SUBJECT: NRC INSPECTION REPORT NO. 70-143/2006-006

SUBJECT: SPECIAL INSPECTION TEAM CHARTER FOR NUCLEAR FUEL
SERVICES (NFS) - DOCKET NO. 70-143 (INSPECTION REPORT
NUMBER 70-143/2006-006)

Nuclear Fuel Services, Inc.
NRC Inspection Report 70-143/2006-006

Figure 1: Event time line showing three previous occasions where either a small amount yellow solution or evidence of yellow solution was found in the bag filter enclosure (ENCLOS-2M05).

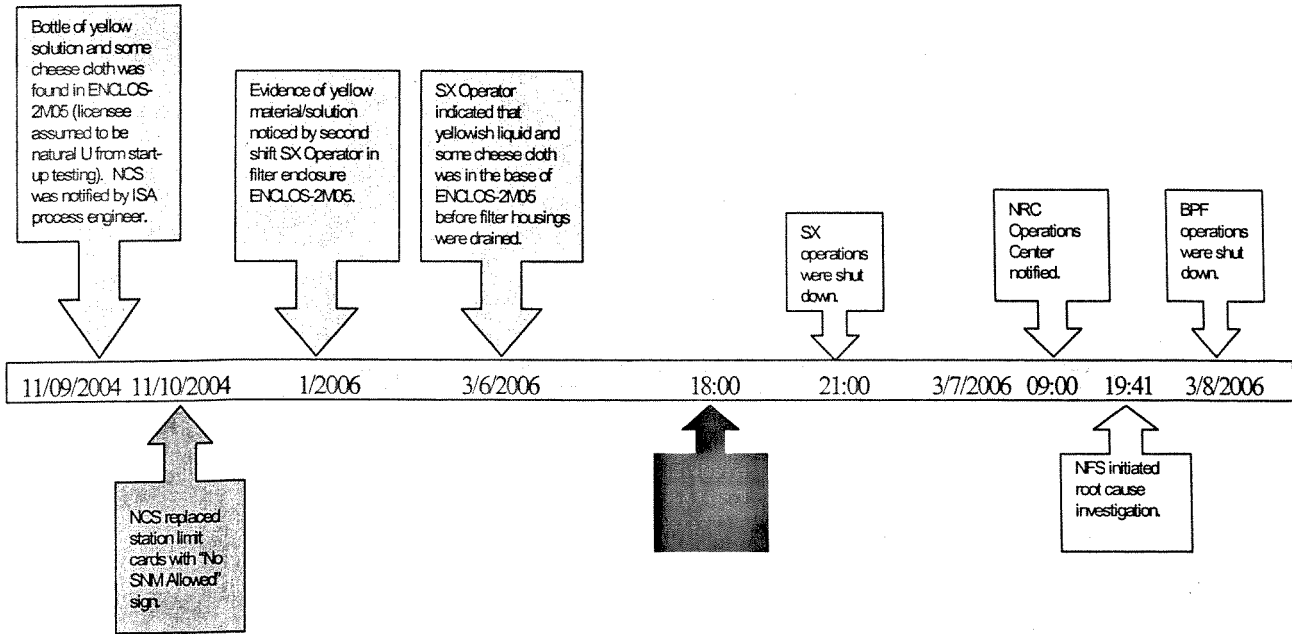
The inspectors noted that there were three previous occasions where either a small amount of yellow solution or evidence of yellow solution was found in the enclosure (see Figure 1). The operators involved reported their observations to their supervisor. The personnel involved thought the material was depleted uranium solution from start-up testing. None of the observed events were reported in the licensee's problem identification, resolution, and correction system (PIRCS).

The inspectors identified three examples, prior to the event, where yellow solution was found in the 2M05 enclosure. Since the enclosure was not approved for use, the presence of yellow solution, possibly uranyl nitrate, was not authorized. In two cases, area supervision was notified, but the issue was not entered into the PIRCS system for formal safety review and was not reported to the Nuclear Criticality Safety function as required by NFS-HS-CL-26. As such, the inspectors concluded that the less-than-rigorous followup to the discovery of yellow solution in three different instances represented lost opportunities to possibly identify and correct the problem before the March 6 spill. The failure to report the events concerning the yellow solution in the 2M05 enclosure in accordance with the requirements of Section 5.1 of NFS-GH-65 is identified as an apparent violation (APV 70-143/2006-006-08).

Figure 2: BPF Tray Dissolver 2M05 Enclosure, Piping and Drains

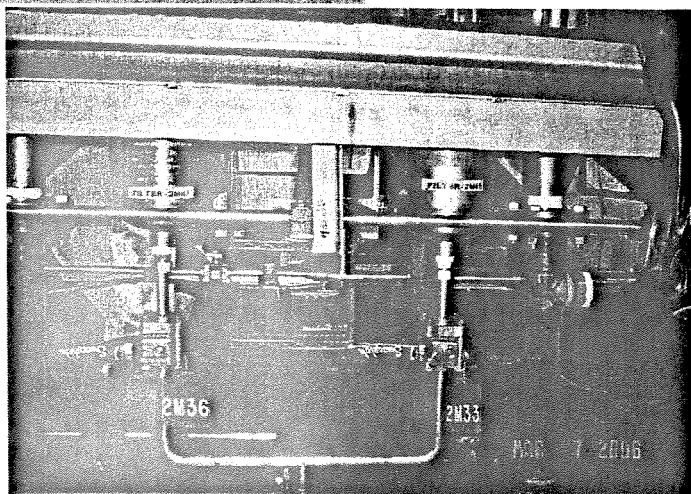
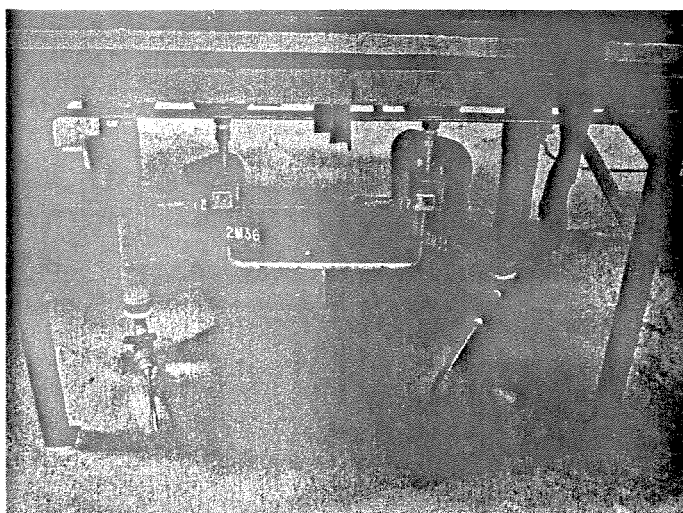
The tray dissolver filter enclosure had two engineered NCS controls consisting of two drains which each had a diameter of two inches. There were no management measures in place to ensure that the drains could adequately perform their safety function. Items such as cheesecloth and poly-bottles which could block the drains were observed in the enclosure prior to the event (see Figure 1). The filter enclosure was considered out of service, and there were no approved procedures for enclosure operations including maintenance operations. No station limit card was in place, and operators were not trained on the unit. The licensee intended to use the enclosure drains as IROFS, and the drains would have been procedurally checked for obstructions prior to each use of the equipment. Other management measures on the drains would have included installation checks and preventive maintenance which were also not performed. The inspectors determined that the filter enclosure was uncontrolled for the accident sequence of a spill into the enclosure because these controls and measures were not implemented. In addition, a spill contained in the enclosure would not be easily noticed such that multiple spills to the enclosure could result in accumulation of fissile solution if the drains were blocked.

The licensee had performed an NCS analysis for the tray dissolver equipment and had prepared an operating procedure. The inspectors observed that the completed and approved NCS analysis for the tray dissolver process had reviewed the potential for accumulation of fissile solution in the enclosure and established appropriate NCS controls for that accident sequence which consisted of two 2-inch drains which were intended to be designated as IROFS. Because the system was considered out of service, the drains required by the analysis were not completely implemented, and double contingency was not established for the accident sequence of fissile solution spill into the tray dissolver filter enclosure. Specifically, verification of proper installation of the drains was not completed. License application Section 4.1.1.1.3 states, in part, that engineered controls must be verified as being properly installed prior to first use with fissile material. Failure to verify proper installation of the tray dissolver filter enclosure drains prior to use of the system with fissile material is identified as an apparent violation (APV 70-143/2006-006-02).

The inspectors noted that the tray dissolver filter enclosure was installed without isolation valves and was connected to fissile process lines, utilities, and ventilation as if the tray dissolver system was in service and would therefore be required to meet the performance requirement of 10 CFR 70.61(d) for accident sequences leading to criticality due to handling fissile material with the tray dissolver equipment. The inspectors determined that because management measures were not implemented for the enclosure drain system, the enclosure did not meet performance requirements for criticality safety relative to accumulation of fissile material in the enclosure or on the floor of the solvent extraction room. Failure to meet the performance requirements of 10 CFR 70.61(d) for accident sequences related to handling fissile material in the tray dissolver system is identified as an apparent violation **(APV 70-143/2006-006-03)**. The inspectors reviewed similar filter enclosures in the plant and observed that they had isolation valves on both sides and an uninterrupted transfer line to the discharge point. No generic issue was identified relative to similar enclosures and equipment in the facility.
